**In Response to CEC & BLM Data Requests 128-141
Set 2, Part 1
Application for Certification (08-AFC-5)
SES Solar Two, LLC**

Subject: SES Solar Two (08-AFC-5)
Responses to CEC and BLM Data Requests 128-141
URS Project No. 27657106.00608

SES Solar Two
In Response to CEC and BLM Data Requests
Set 2, Part 1
Data Requests 128-141
08-AFC-5

CREATED BY: LG DATE: 05-22-09 FIG. NO: 134-4

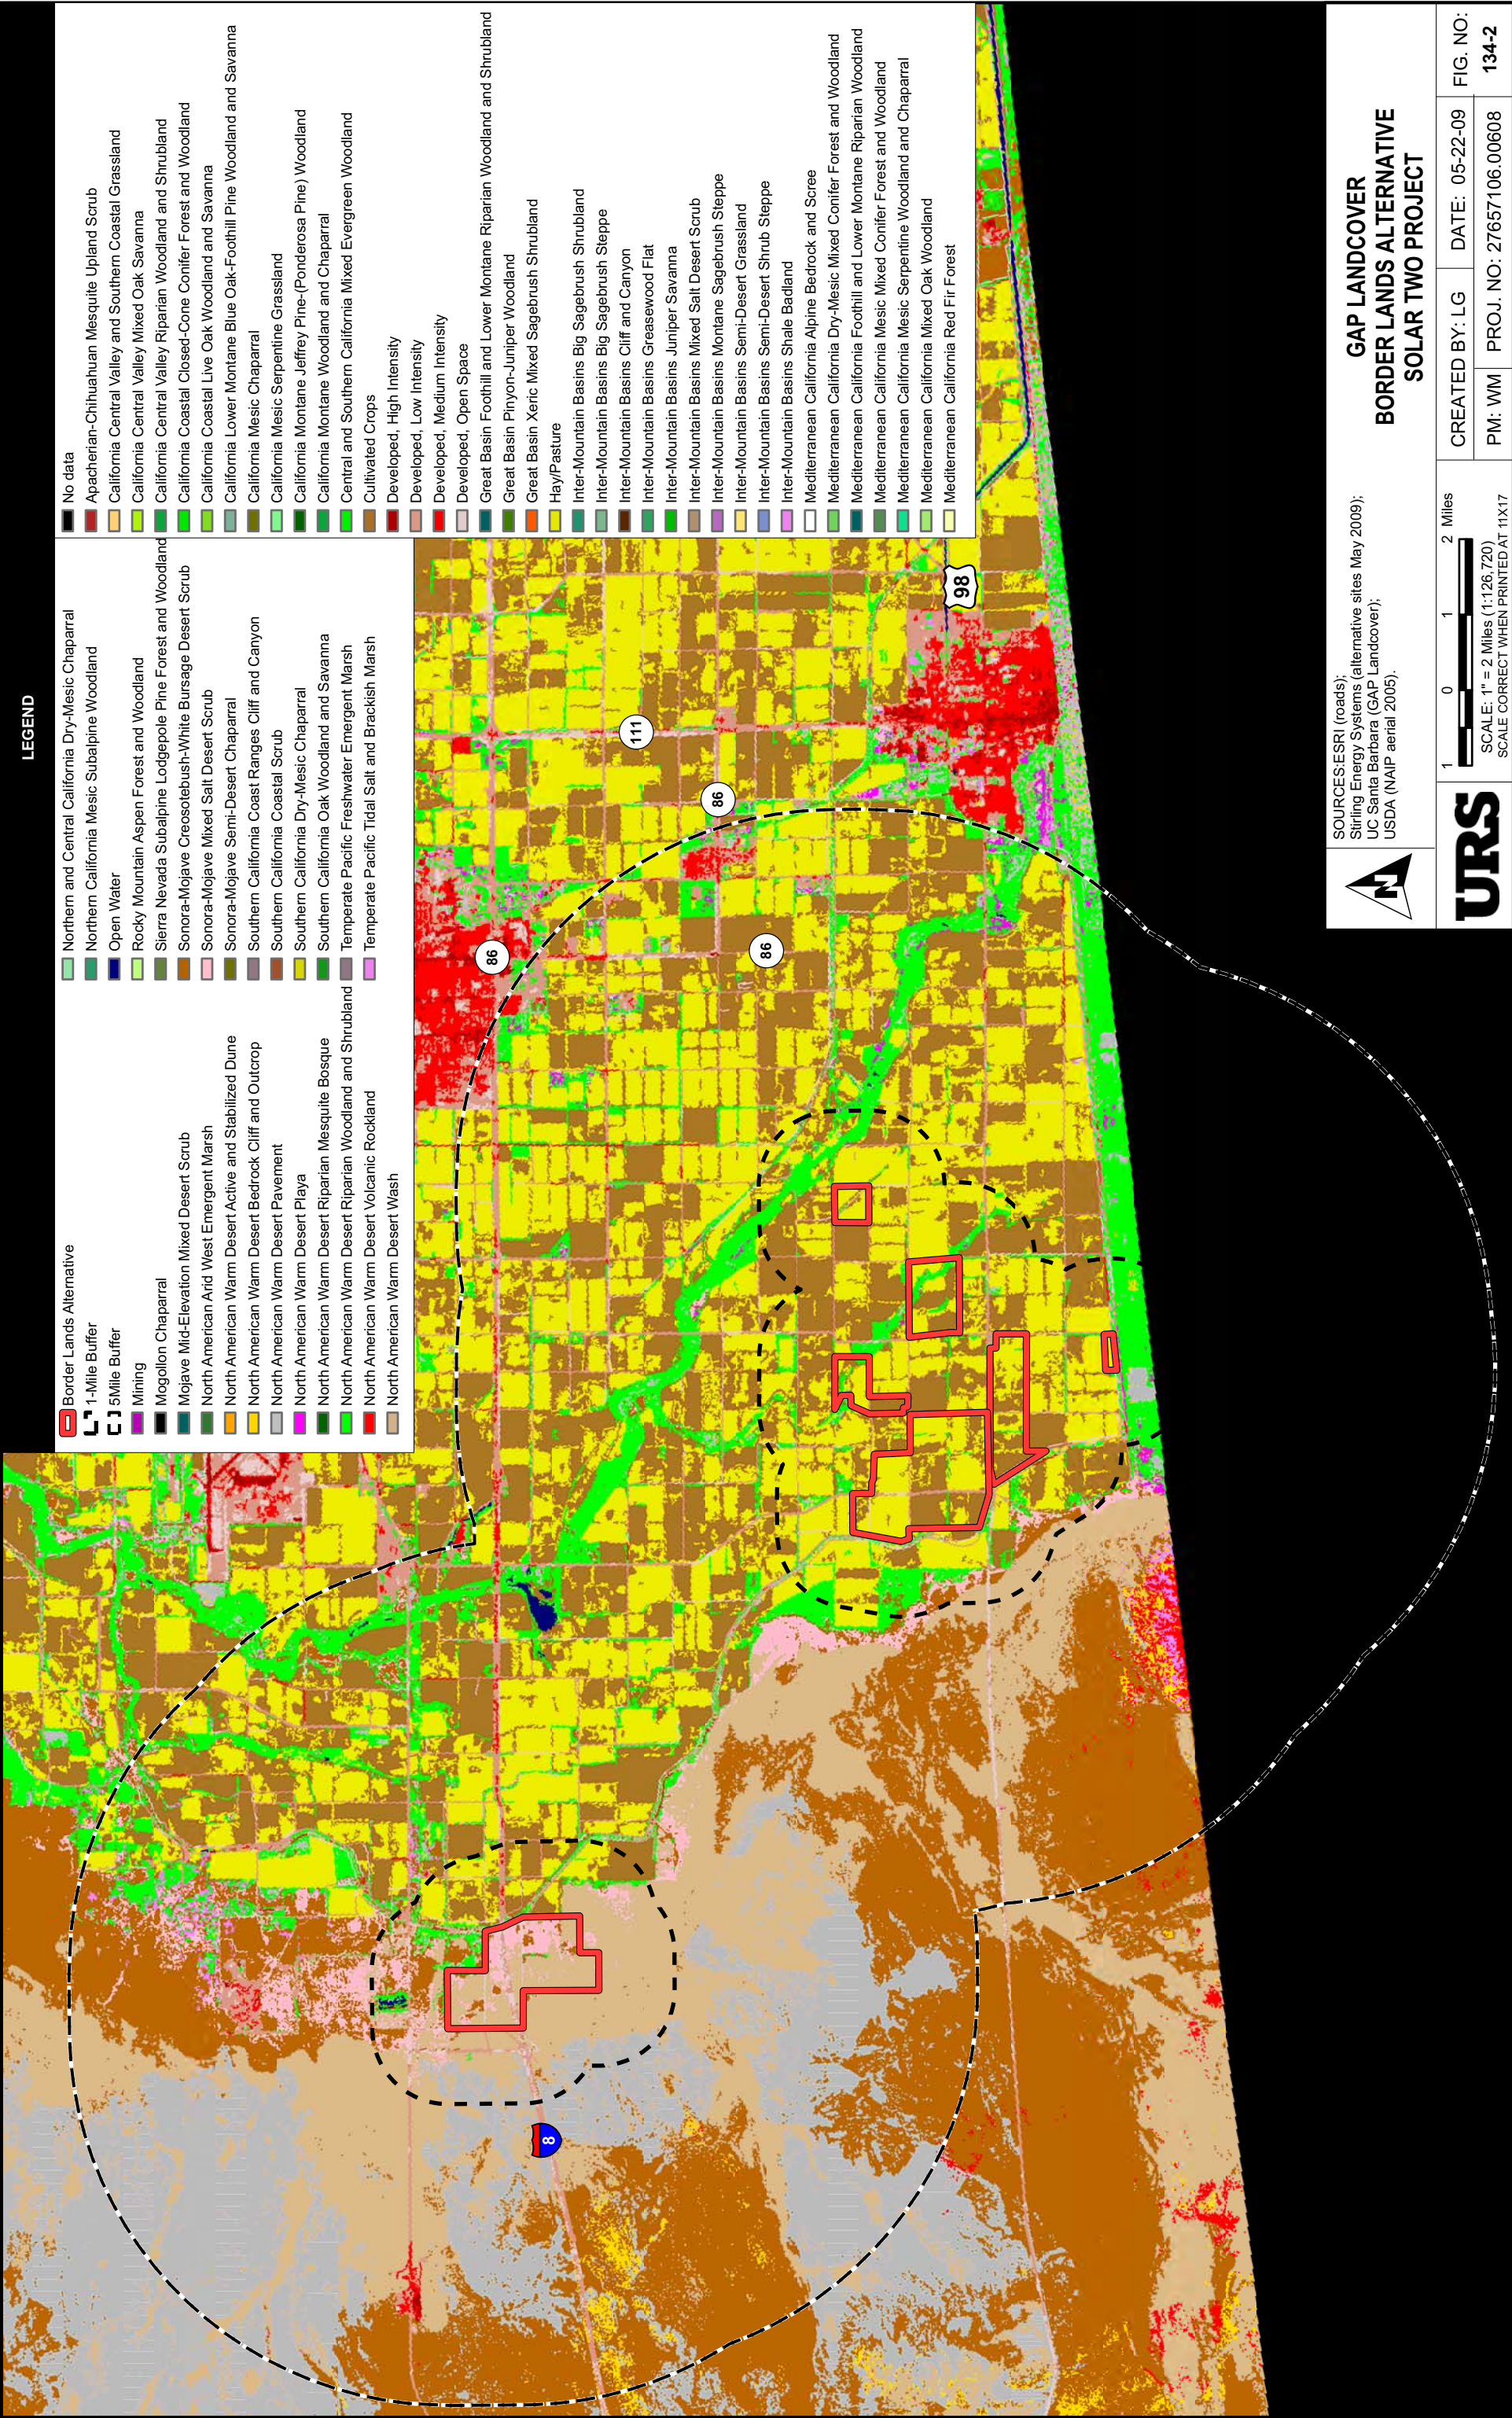
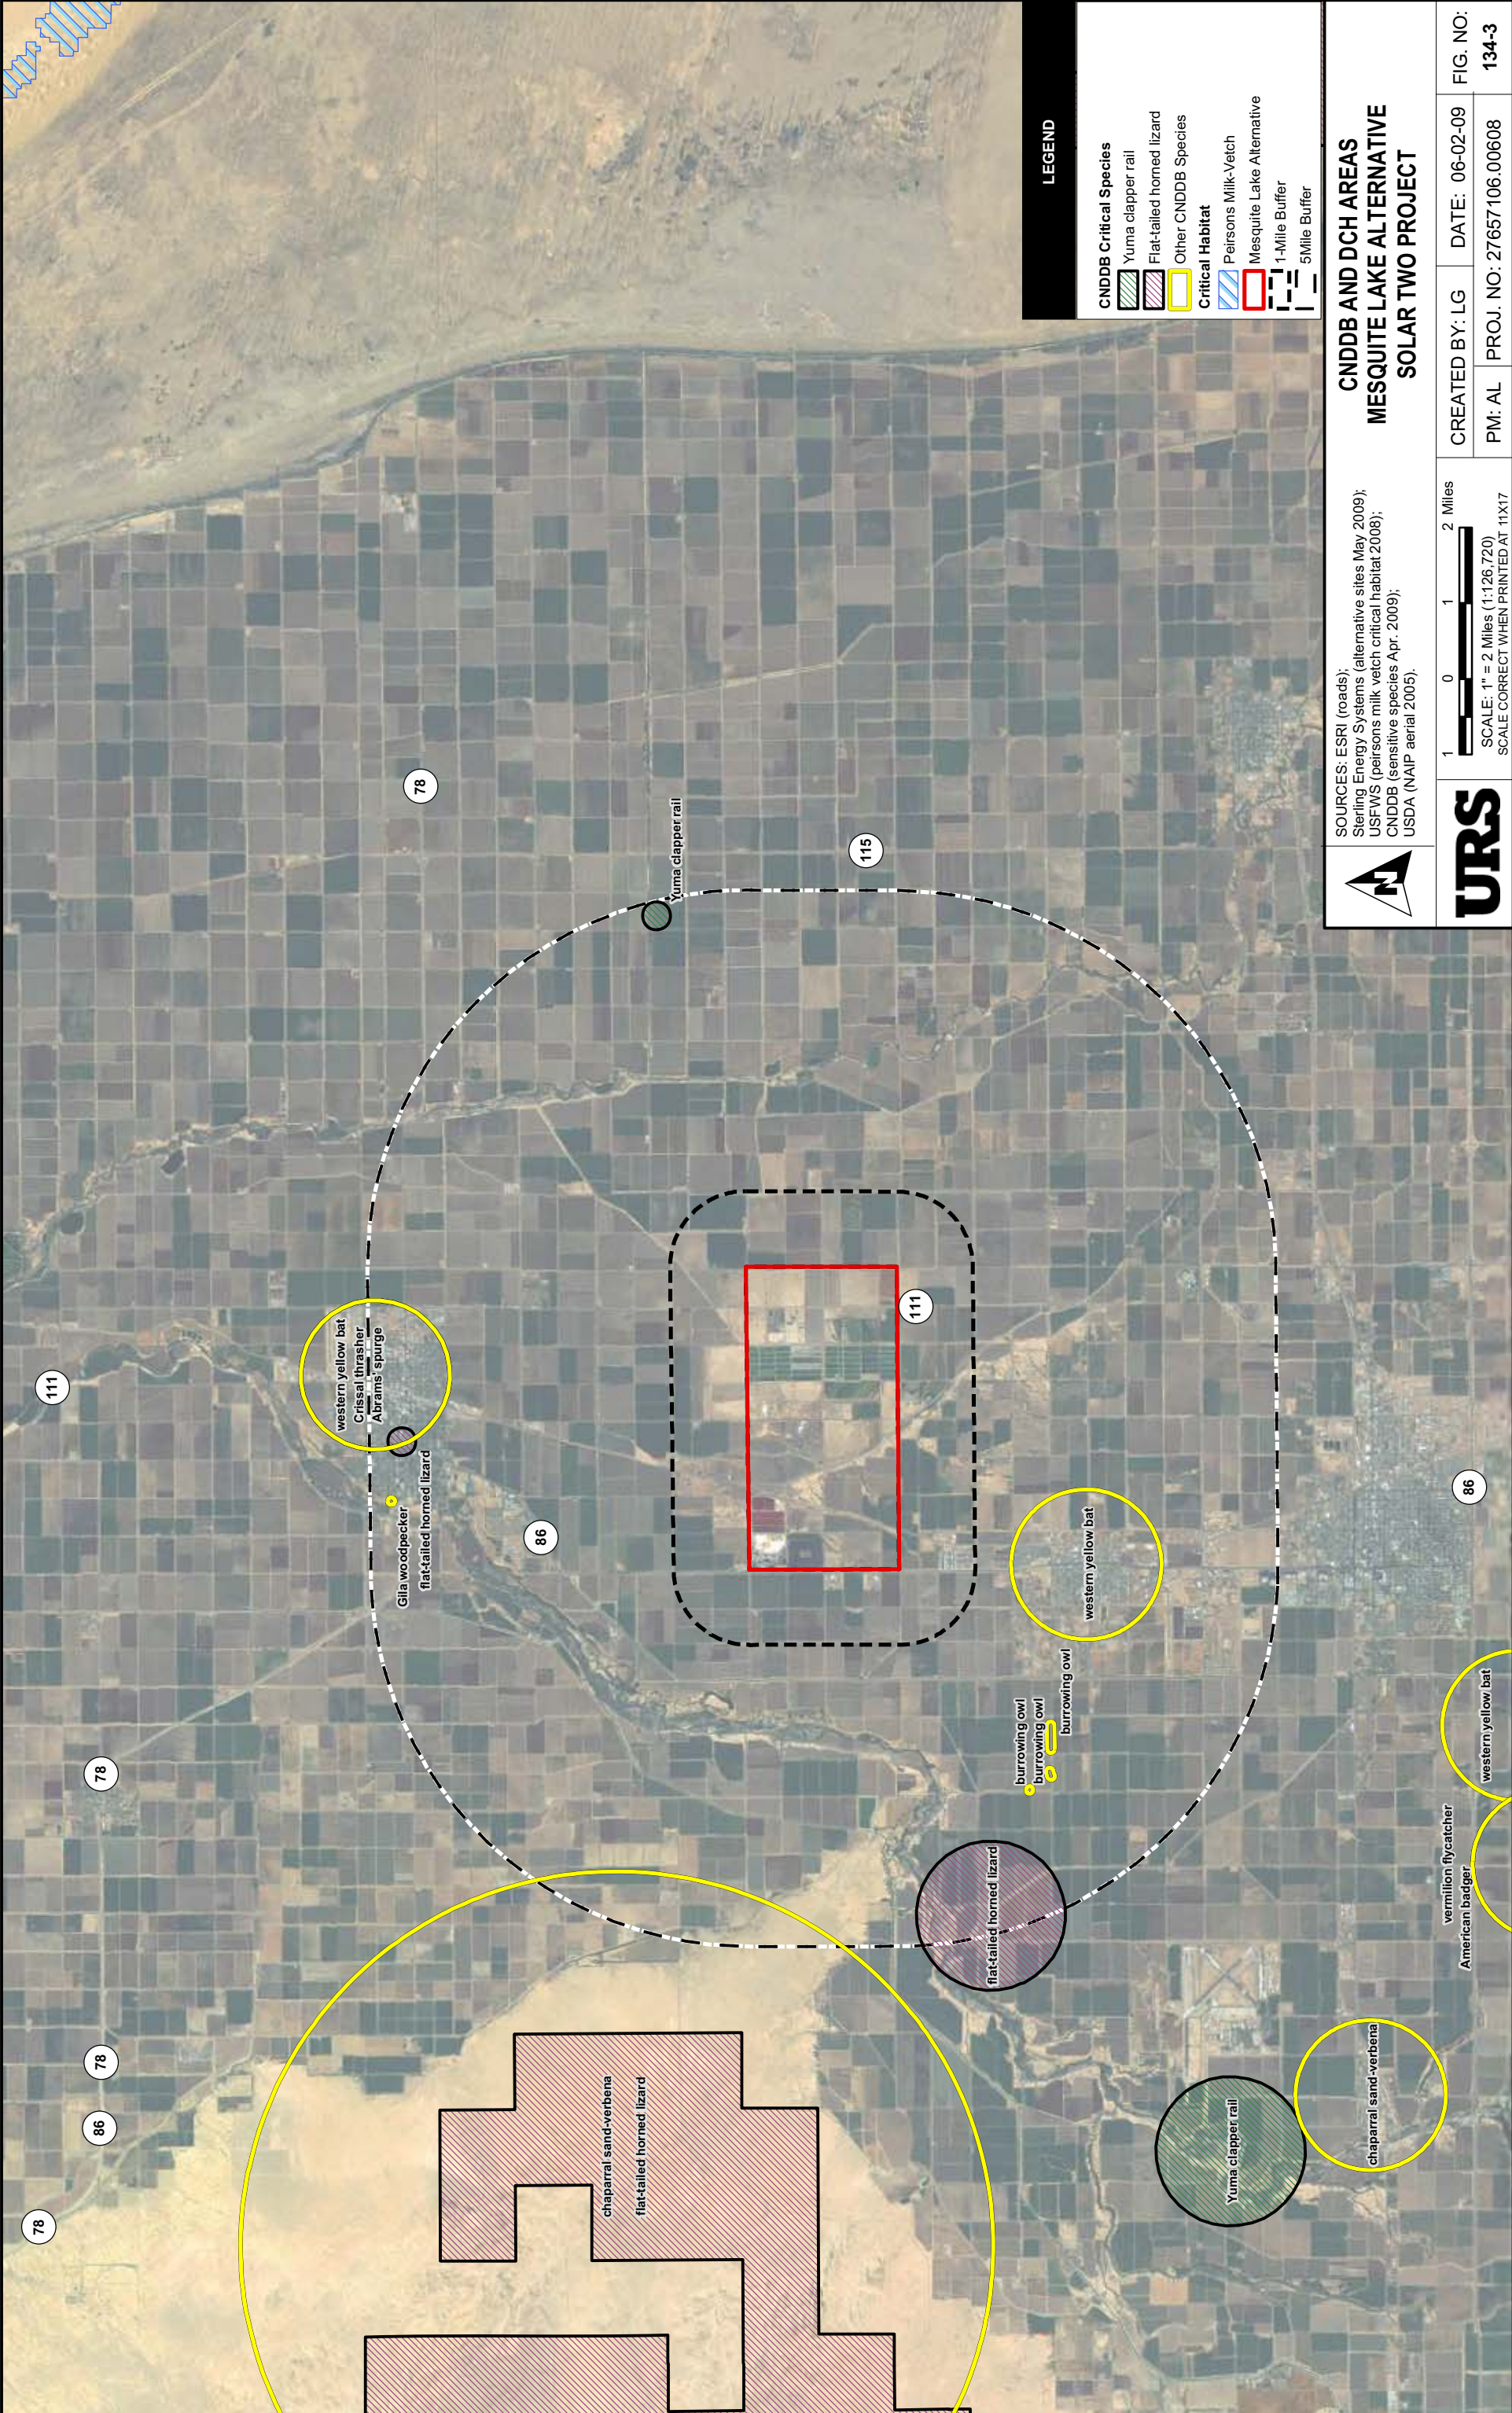
- **Biological Resources:** One of the site selection criteria for the proposed SES Solar Two site was to avoid highly pristine or biologically sensitive areas. In order to assess this criterion for the alternative sites, please provide the results of the CNDDDB search for the South of Hwy SR 98 site, the Mesquite Lake Alternative, and the Border Lands Alternative.
- **Cultural Resources:** Due to the extensive cultural resources present at the proposed SES Solar Two site, alternative sites are being sought that may impact fewer cultural sites while still achieving the required site criteria. Please provide an Information Center search (Class I) for recorded sites identified within the potential South of Hwy SR 98 site, the Mesquite Lake Alternative, and the Border Lands Alternative.

Mesquite Lake Alternative

The primary land cover of this alternative site is active and inactive agricultural lands, with some apparent desert scrub and arid riparian habitats. No sensitive species sightings occur within the immediate vicinity. Burrowing owl is likely to be present. A major drainage passes through the site. Please see Figures 134-3 and 134-4, provided behind this response as attachments BIO-4 and BIO-5, respectively.
